Subject: U-Scan CashCode Bill Acceptor – New Firmware (Canada)

Update A: The firmware CA1520 was released to allow acceptance of the new Canadian \$50 note, however a poor acceptance rate was identified. This new firmware CA1521 is now released to improve the acceptance rate of the new note.

Procedure to Update Firmware on CashCode SM Bill Acceptors (Canada)

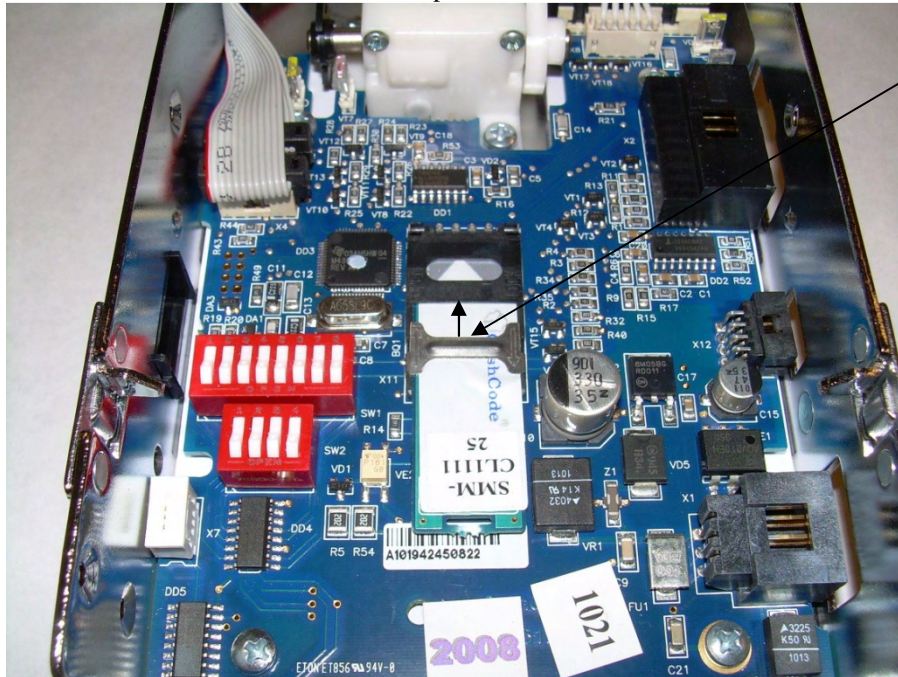
1. Power off unit.
2. Remove Validator cover by lifting the left side of the cover and pulling upward.

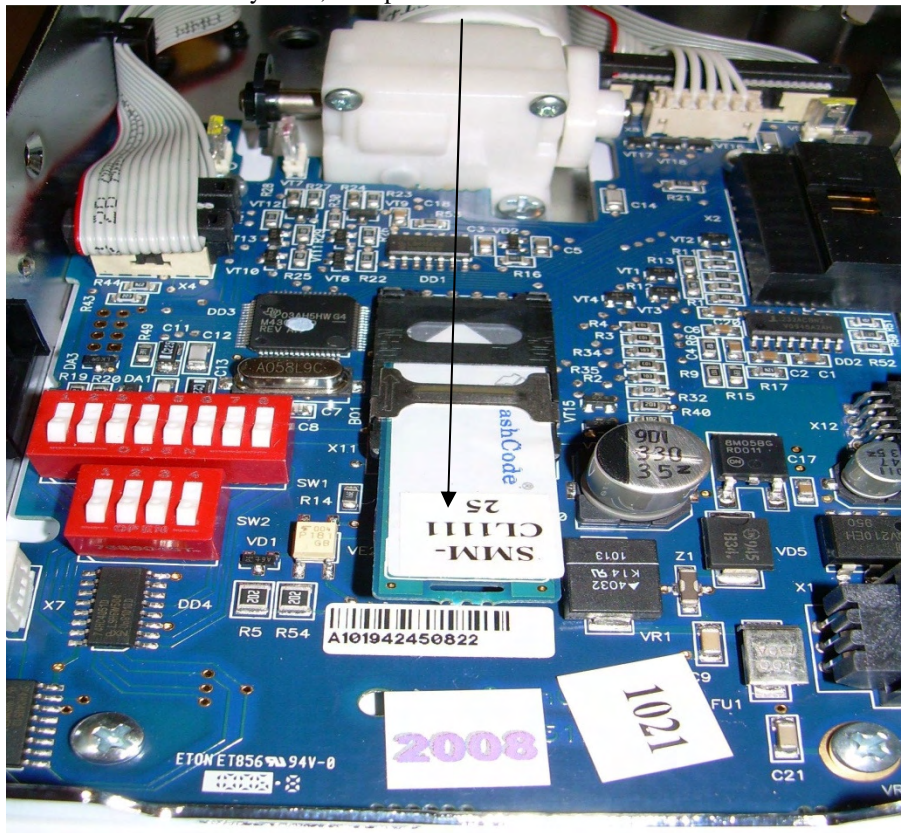
- With the Validator cover removed from the unit, remove current memory stick by sliding the metal clip toward the plastic socket.

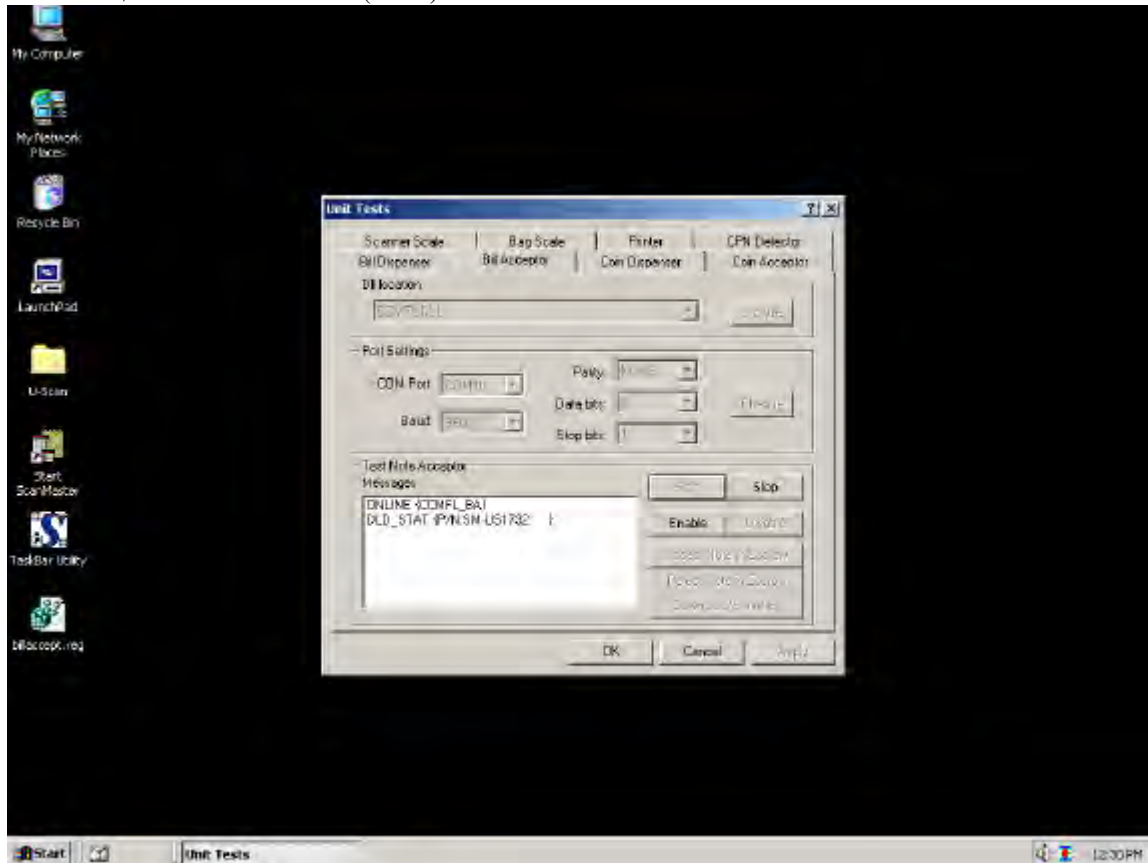
- Inset memory stick CA1521 (11004433) into the socket by holding down the stick while sliding into place, then sliding the retaining clip back into place to lock the memory stick.
- Power on unit. Indicator lights on the front of unit will flash Red & Green while firmware is downloaded from the CA1521 memory stick.
